**Advanced Passive 1000 (AP1000)
Generic Technical Specification Traveler (GTST)**

Title: Changes Related to LCO 3.0, Limiting Conditions for Operation (LCO) Applicability

Figure B 3.0-1
Configuration of Trains and Systems

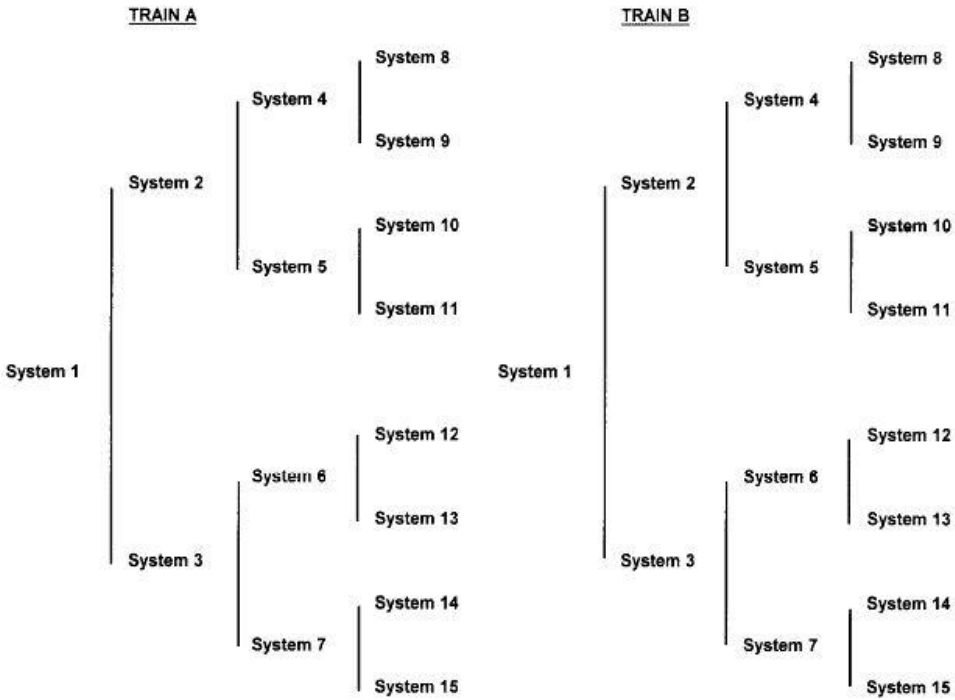
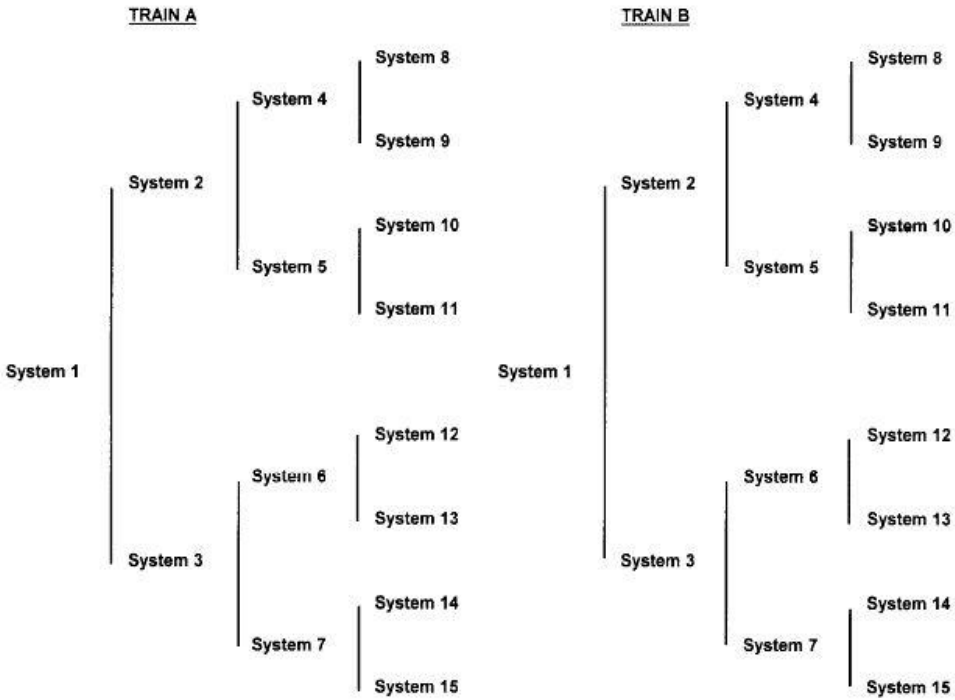
Examples of a loss of safety function when a support system is inoperable and a Figure are added to the LCO 3.0.6 Bases. The application of LCO 3.0.6 is a cause of confusion. Examples and a figure help clarify the appropriate application of LCO 3.0.6. (TSTF-71-A)

Examples that discuss Figure B 3.0-1 in the bases of LCO 3.0.6 are revised to more accurately describe a loss of safety function and to be internally consistent. Example inconsistencies are confusing and should be corrected in order for the bases to be a useful tool in understanding the TS. (TSTF-494-T)

Example B 3.0.6-1, Example B 3.0.6-2, and Example B 3.0.6-3 are added by TSTF-071-A, Rev. 2 (and subsequently revised by TSTF-494-T), along with Figure B 3.0-1, to provide better clarity for the application of LCO 3.0.6. An introductory paragraph is added to the examples to provide guidance to the reader in the use of the examples.

Figure B 3.0-1 and the accompanying discussion, including Examples B 3.0.6-1, B 3.0.6-2, and B 3.0.6-3, were added by TSTF-71, Rev. 2 and approved by the NRC on 10/27/1998. The purpose of the figure and the examples is to clarify the discussions of a loss of safety function and cross train checks.

Examples B 3.0.6-1, B 3.0.6-2, B 3.0.6-3, and Figure B 3.0-1 are added by TSTF-071-A, Rev. 2 to provide additional clarity to the application of LCO 3.0.6. The examples use Figure B 3.0-1 to illustrate loss of safety function conditions that may result when a support system is inoperable. These changes are a Bases-only change and provide clarity.
